PCN No#: 051222-1

PCN Title: Add a new lead frame source for SOT-523 and SOT-723 package

PRODUCT CHANGE NOTICE

SOT-723

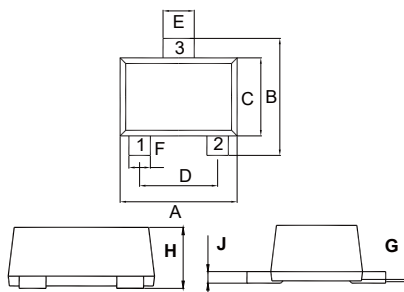
new lead frame source for SOT-723 package:SI3134K-TP,SI3139K-TP

DIM	INCHES		MM		NOTE	Actual measurement
	MIN	MAX	MIN	MAX		
A	0.043	0.051	1.10	1.30		1.189
B	0.043	0.051	1.10	1.30		1.188
C	0.028	0.035	0.70	0.90		0.803
D	0.031		0.80		TYP.	0.805
E	0.009	0.017	0.22	0.42		0.249
F	0.005	0.013	0.12	0.32		0.236
G	0.000	0.002	0.00	0.05		0.022
H	0.017	0.021	0.43	0.54		0.444
J	0.003	0.006	0.08	0.15		0.109

SOT-523

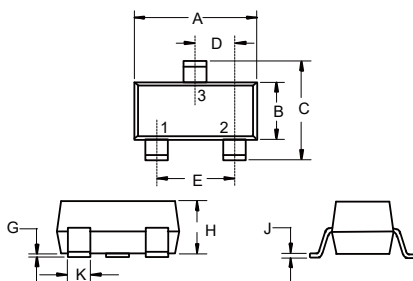
new lead frame source for SOT-523 package:SI3134KE-TP

DIM	INCHES		MM		NOTE	Actual measurement
	MIN	MAX	MIN	MAX		
A	0.059	0.067	1.50	1.70		1.61
B	0.030	0.033	0.75	0.85		0.81
C	0.057	0.069	1.45	1.75		1.62
D	0.020		0.50		TYP.	0.502
E	0.035	0.043	0.90	1.10		1.00
G	0.000	0.004	0.00	0.10		0.05
H	0.024	0.031	0.60	0.80		0.76
J	0.004	0.008	0.10	0.20		0.15
K	0.006	0.014	0.15	0.35		0.32
